January 2, 2003

**Re: GE-Pittsfield/Housatonic River Site  
Former Oxbow Areas J and K (GECD420)  
Addendum to Pre-Design Investigation Work Plan**

ADDENDUM TO PRE-DESIGN INVESTIGATION WORK PLAN FOR  
FORMER OXBOW AREAS J AND K REMOVAL ACTIONEXISTING SOIL PCB DATA AND PROPOSED USAGE

PROPOSED AND EXISTING PCB CHARACTERIZATION LOCATIONS

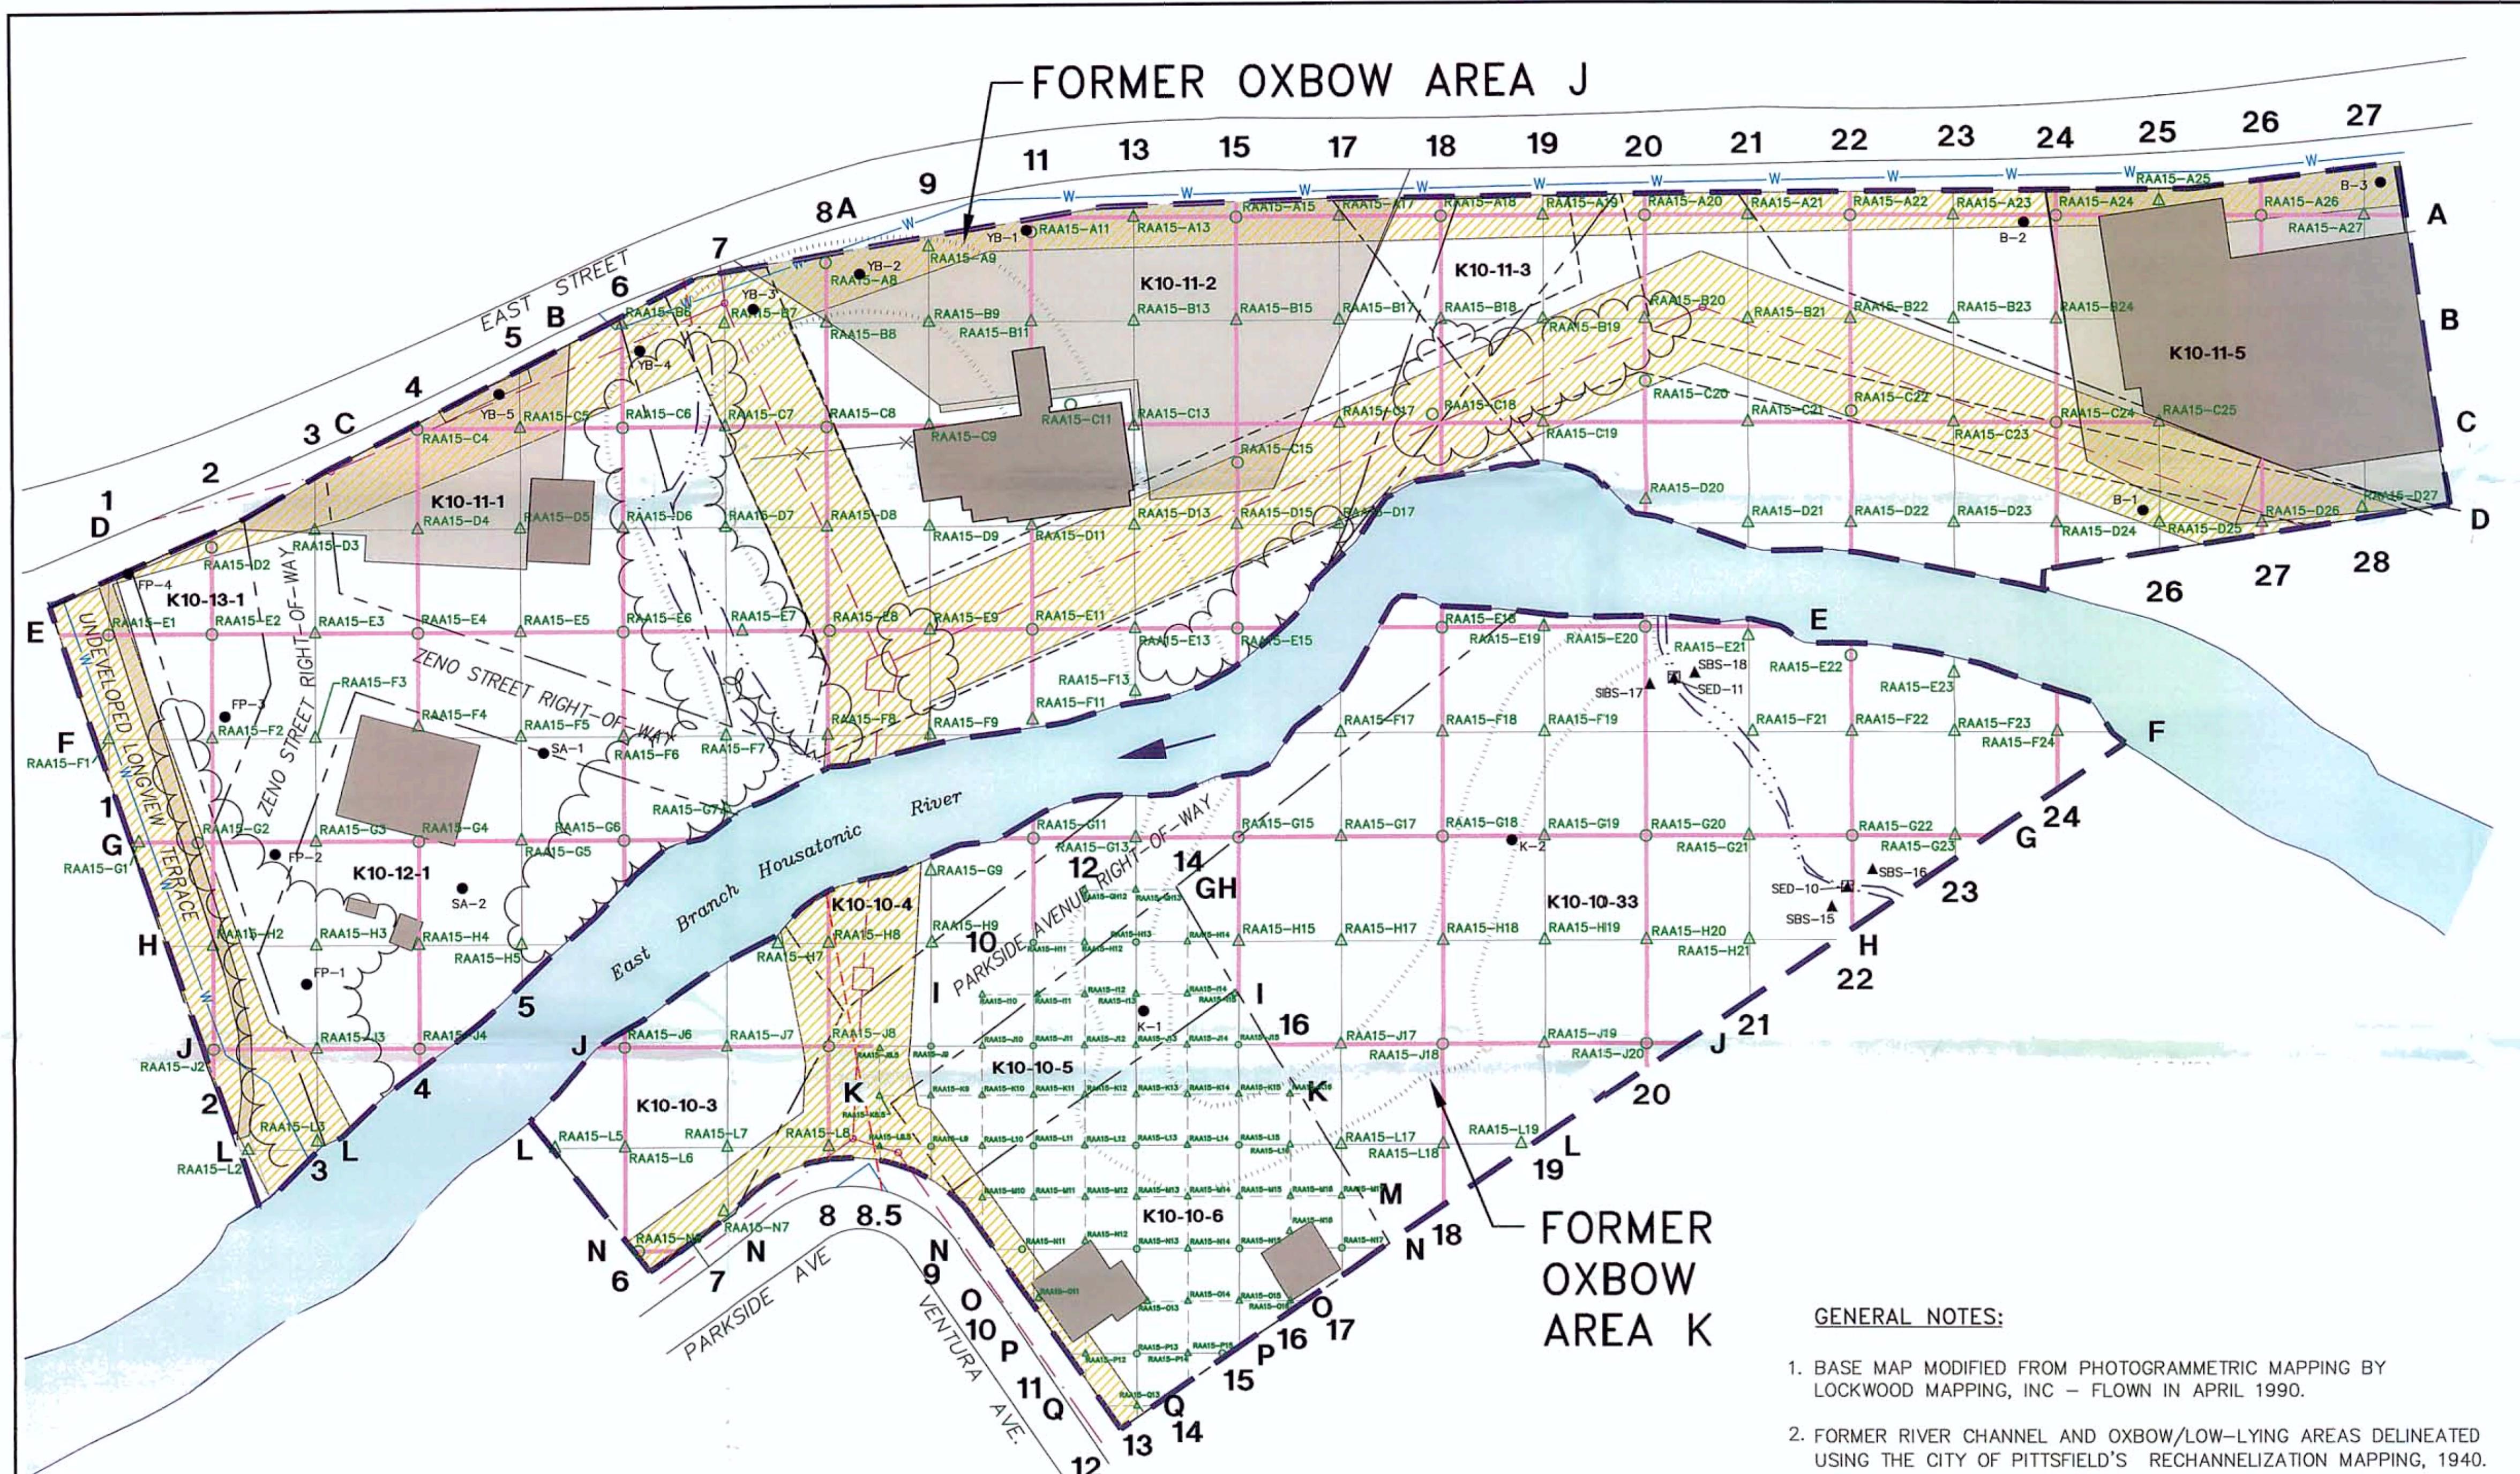
Based on the information summarized above, GE proposes one change in the pre-design soil sampling related to characterization of soils near subsurface utilities. In its conditional approval letter, EPA directed GE to install a soil boring at sample RAA15-D3 to provide additional subsurface soil PCB characterization for the utility corridor in this area. However, GE instead proposes to advance a soil boring at RAA15-D2 to provide better spatial coverage within the utility band. Revised Tables 3A and 4A and Figure 4 (attached) reflect this proposed change.

2. Condition No. 2 of EPA's conditional approval letter provides clarification regarding the characterization of several undeveloped streets and right-of-ways. These changes result in several modifications to the proposed pre-design investigations, as detailed in item iv of this EPA condition. The tables and figures attached to this Addendum reflect the changes identified by EPA in its Comment No. 2.iv. In addition, GE has added two additional surface soil samples in the vicinity of Parcel K10-10-5 -- RAA15-J8.5 and RAA15-L8.5, as shown in attached Tables 3B and 4B and Figure 4.

4. Condition No. 4 of EPA's conditional approval letter requires that GE collect samples to a depth of 15 feet at all 14 boring locations at residential Parcels K10-10-5 and K10-10-6 for PCB characterization. It also states that GE may analyze the samples from these borings for PCBs using an iterative approach, in which samples are analyzed in successively deeper increments until PCBs are not detected and field headspace readings do not exceed background in a deeper sample interval. Consistent with this condition, GE will collect the samples from the borings on these residential properties (which now total 15 borings, given the expansion of Parcel K10-10-5 per EPA Condition No. 2.iii) to a depth of 15 feet, as shown in attached Tables 3B and 4B and

Figure 4. GE will direct the laboratory to initially analyze the samples from the 0- to 1-foot, 1- to 3-foot, and 3- to 5-foot depth increments for PCBs. If the deepest of these samples does not show detected PCBs and field headspace readings do not exceed background (i.e., above ambient levels as measured with a portable photoionization detector [PID]), no deeper samples will be analyzed for PCBs. However, if either of these conditions is not met, the samples from deeper increments will be analyzed on an iterative basis until such conditions are achieved.
